Wollongong Local Planning Panel Assessment Report | 14 November 2019

WLPP No.	Item 3
DA No.	DA 2019/445
Proposal	Demolition of existing structures and construction of new dwelling house, gazebo, fence and retaining walls
Property	Lot 7, DP 732449, 2-4 Reef Ave Wombarra
Applicant	Mr Thom Silvius
Responsible Team	Development Assessment & Certification - Building and Certification Team (GH)

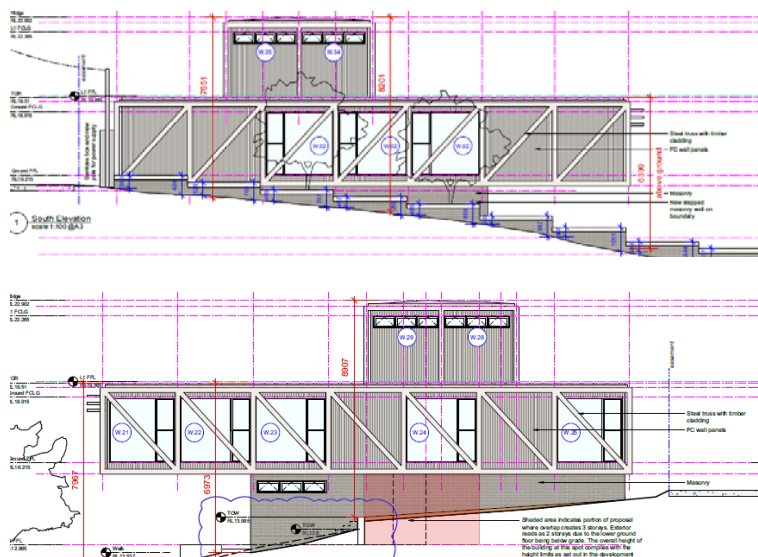
The proposed dwelling contains three storeys.

This site has a fall of 8m diagonally across the site and a change of levels of approximately 3 metres down the building footprint.

As the building descends the site the uppermost level overlaps the lowest level causing a 4.7m section to contain three storeys. Council approved variations to the three level provision of the DCP are not uncommon on sloping sites where the third level is formed by an overlap of levels.

The lower level at this point is partially below ground level.

DA108

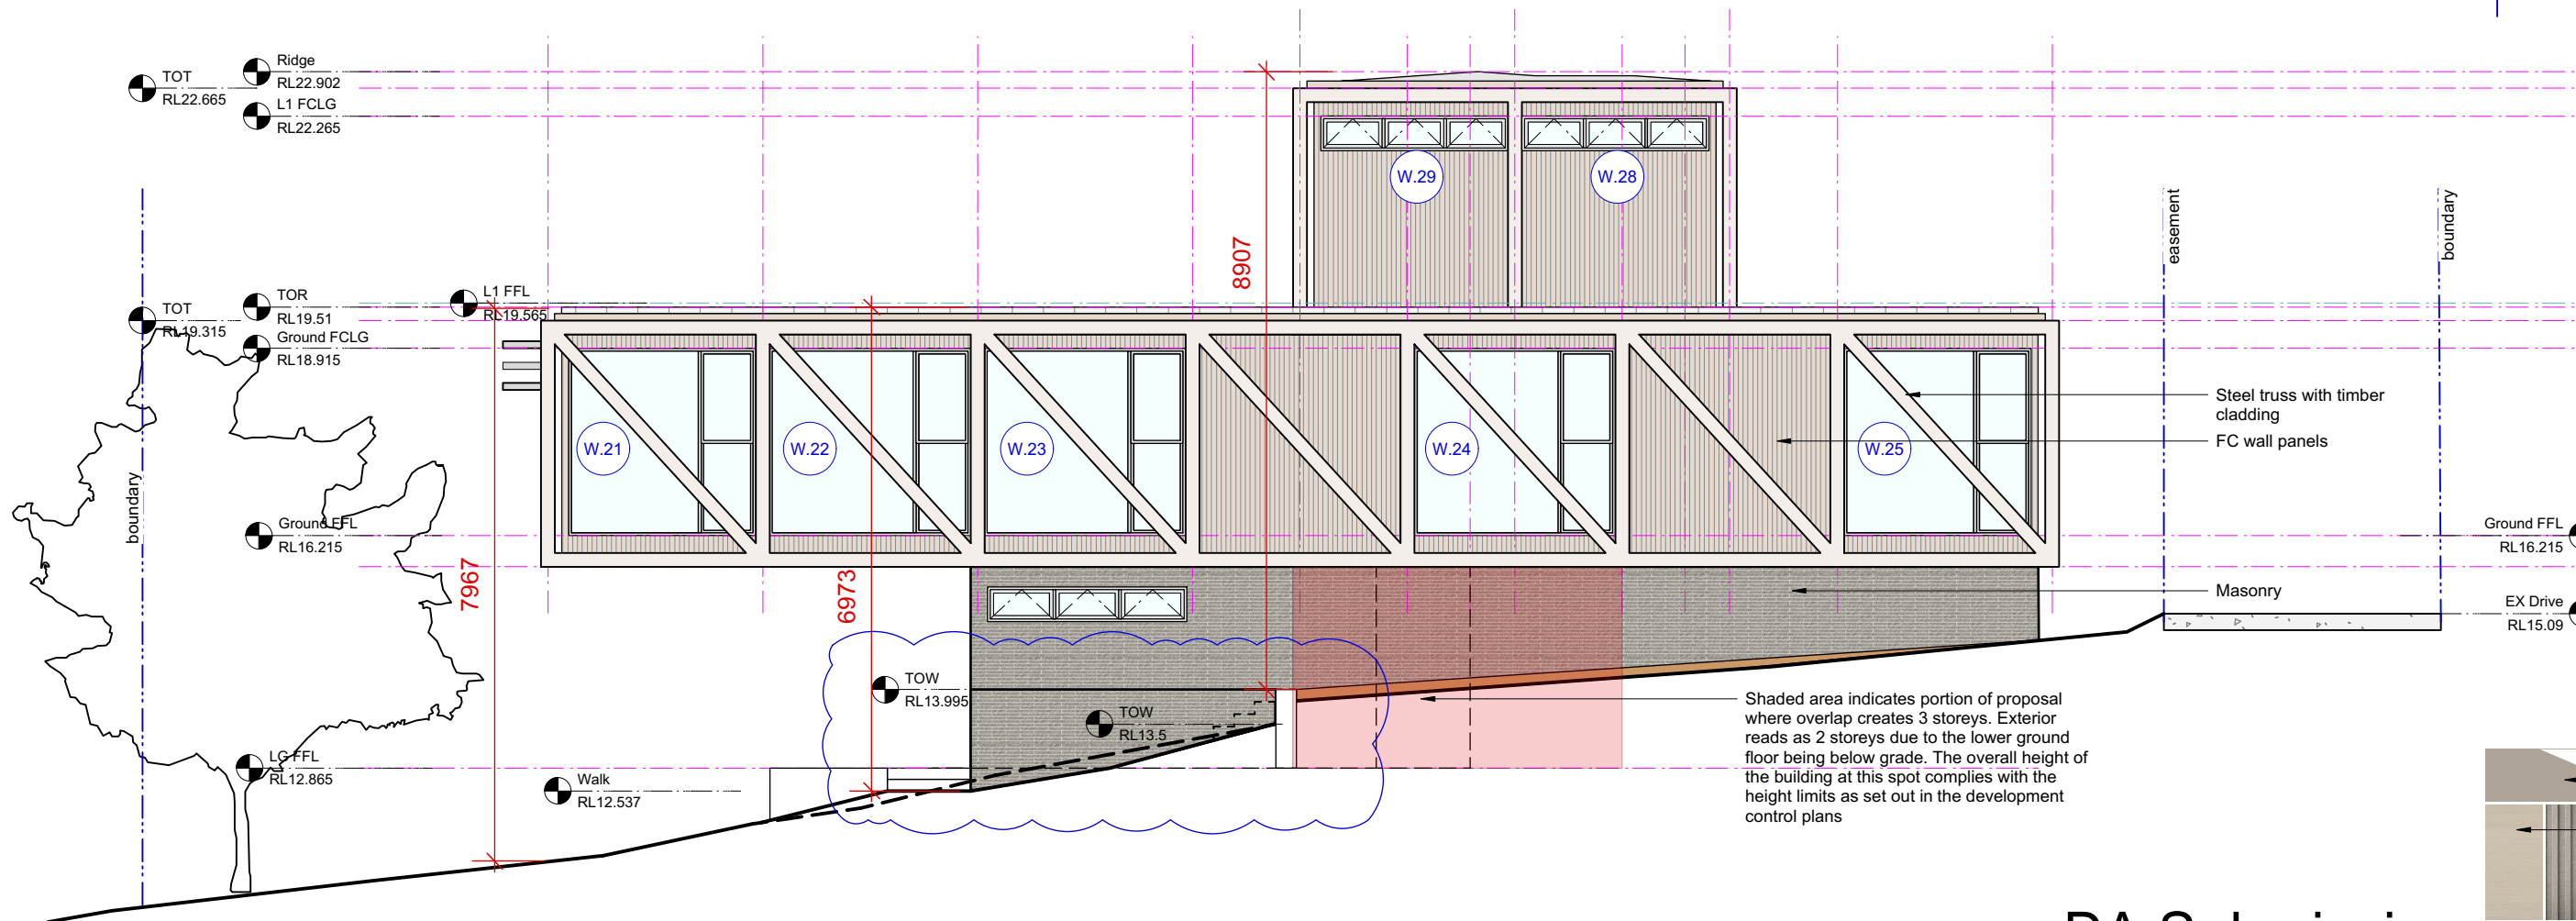
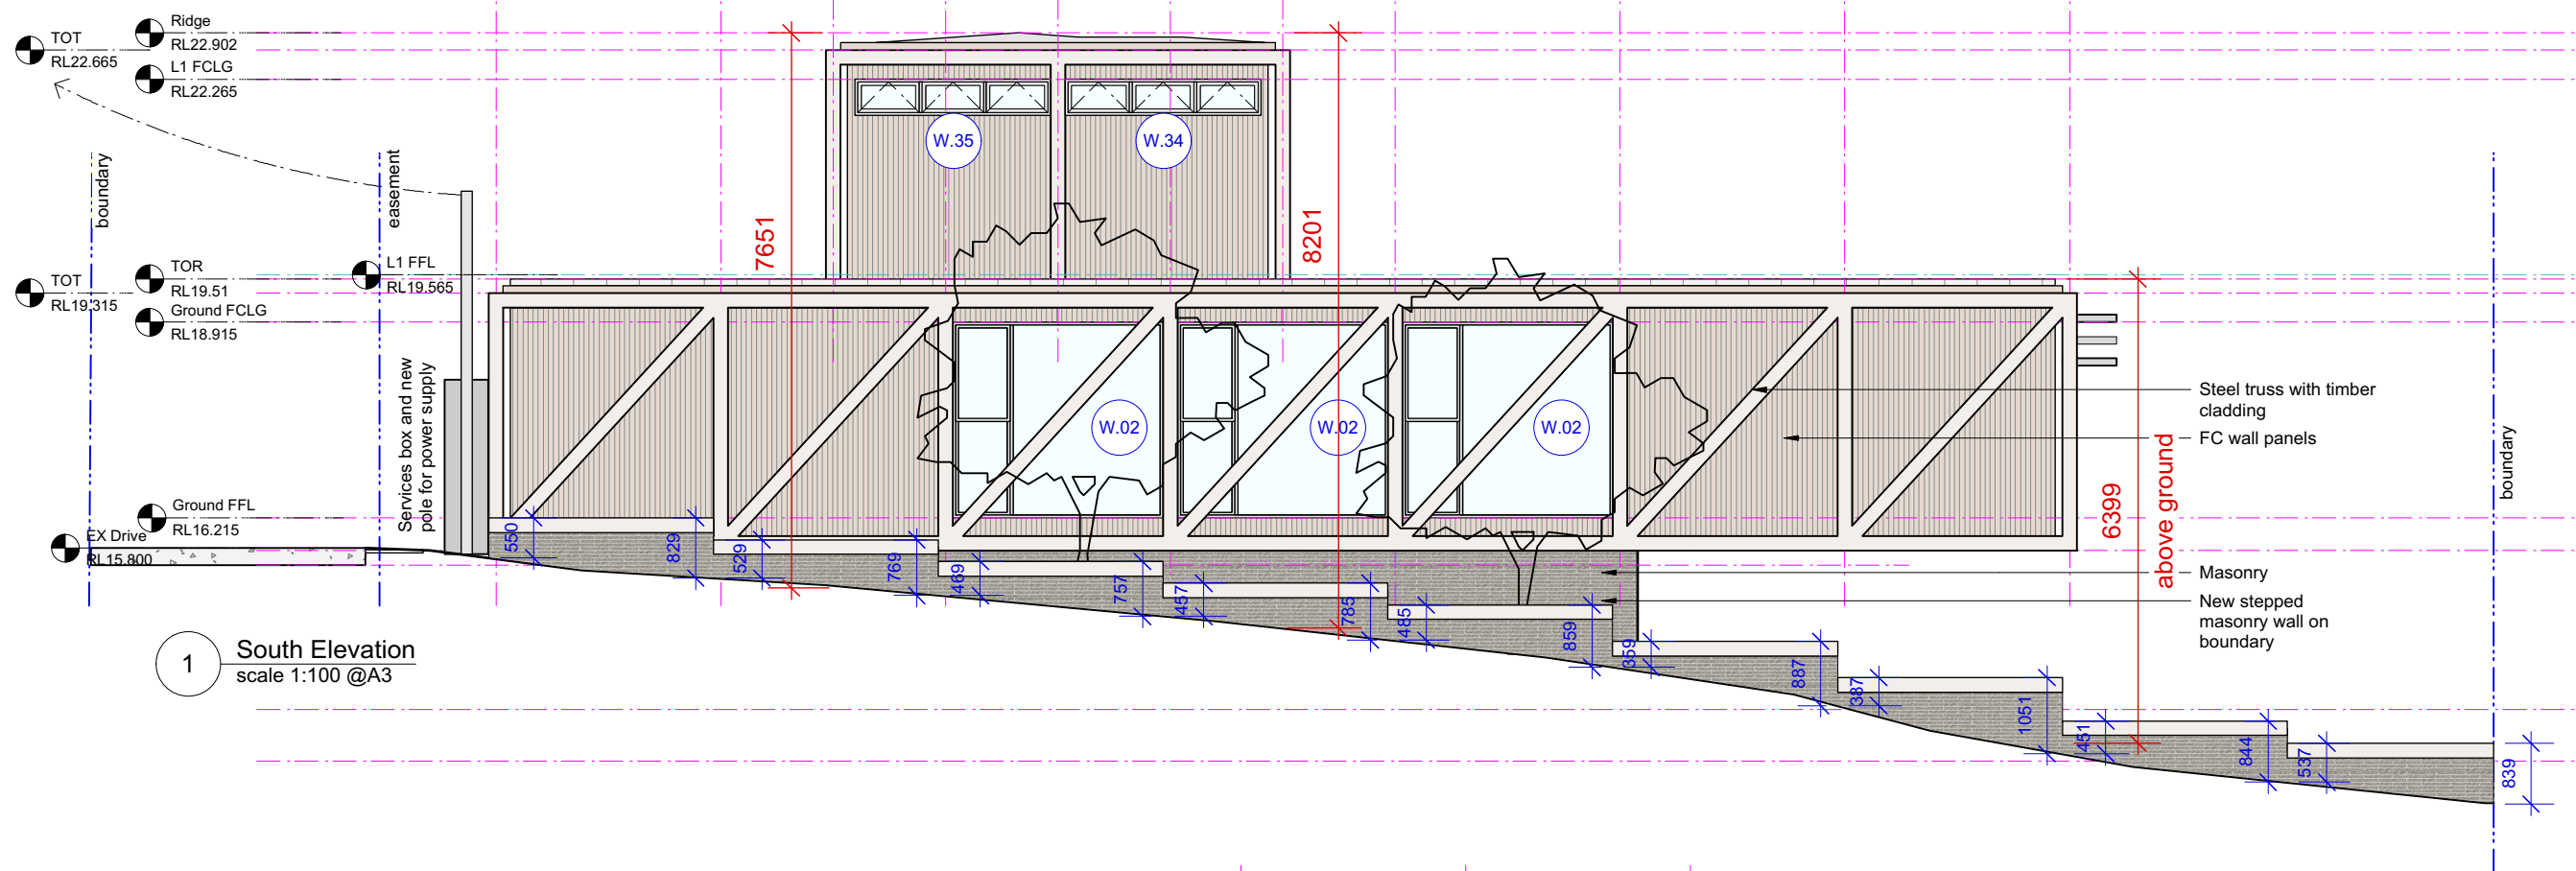
<p>The stepped Masonry fence and retaining walls could simply use a more sympathetic material such as reclaimed stone from the existing walls or new sandstone to lessen impacts on the coastal character of the site, which is in a highly prominent position. I note that the dry stacked walls also continue west along Reef Street. Therefore masonry is not considered an appropriate material for the stepped fencing.</p>	<p>The application includes a stepped masonry wall along the street frontage having a height less than 1m at critical points.</p> <p>The applicant has expressed concern regarding the safety of the existing roughly assembled stone wall where stones have fallen from it.</p> <p>A low masonry fence will comply with Wollongong DCP Chapter B1 cl 4.9.</p> <p>A more onerous requirement is not justified in this instance.</p> <p>Heritage officers confirm the stone wall is not a Heritage item.</p> <p>In addition to a loose stone fence at 6-8 reef Ave other front fences in this street include;</p> <ul style="list-style-type: none"> • a high brushwood fence directly opposite at 1-3 Reef Ave • a painted picket fence 14 Reef Ave • an 800mm high concrete block retaining wall under construction at 5 Reef Ave. (approval for 430mm brickwork with 770mm powder coated aluminium panel above – DA 2014/795) <p>Legislation</p> <p>Clause 4.15 (3A) of the EP&A Act states that <i>if a development control plan contains provisions that relate to the development that is the subject of a development application, the consent authority:</i></p> <p><i>(a) if those provisions set standards with respect to an aspect of the development and the development application complies with those standards—is not to require more onerous standards with respect to that aspect of the development,</i></p>

4.9 FENCES		
	Yes	Very low stepped masonry fence along front boundary (sheet DA 108) complies DCP.
